Application : 10/047928

EXAMINER'S AMENDMENT

IN THE DRAWINGS:

FIG. 1
PRIOR ART

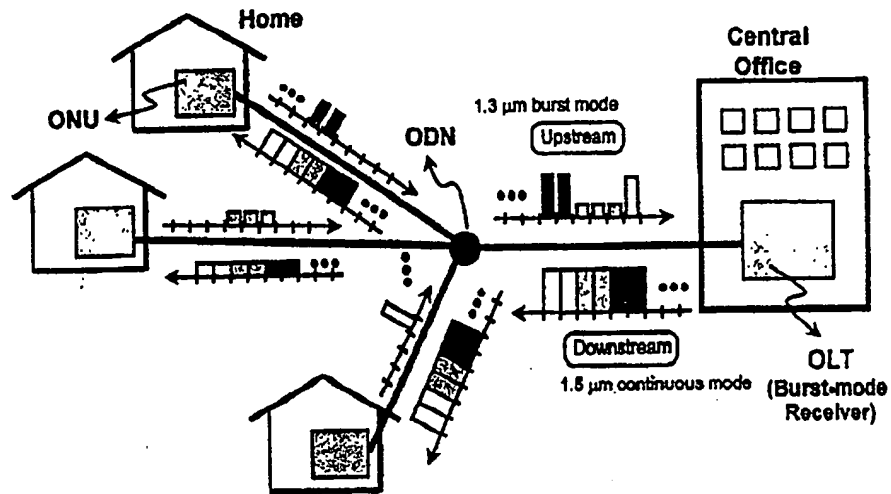
- In figure 1, a label "PRIOR ART" is added to the figure.
- In figure 2, a label "PRIOR ART" is added to the figure.
- In figure 3, a label "PRIOR ART" is added to the figure.
- In figure 4A, a label "PRIOR ART" is added to the figure.
